# Planning Commission

## Planning Commission Meeting Agenda Hartland Township Hall Thursday, January 13, 2022 7:00 PM

# Hartland Township Planning Commission Meeting Agenda Memorandum

**Subject:** Site Plan with Special Land Use Application #22-001 (Automobile fueling and convenience station - Clyde Road)

**bicycle rack**  
LANDSCAPE FORMS: FGP BIKE RACK  
SCALE: 1" = 1'-0"

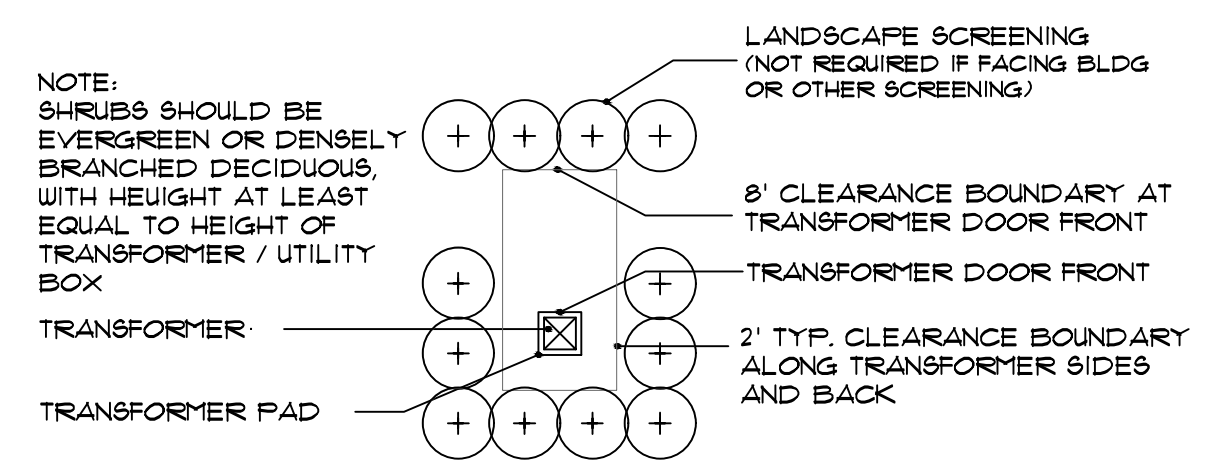
Please see below in red responses needed for the staff report. Also attached above are sheets LS100, A100 and A001. LS100 is revised per the last review. Sheet A100 is revised to show barrier free signs locations. A sign detail was added. The distance between the curb and column need to be a minimum of 3'-0" in width , which is provided. Sheet A001 is provided. They are the renderings for the building. A material board will be provided at the date of the Planning Commission meeting.
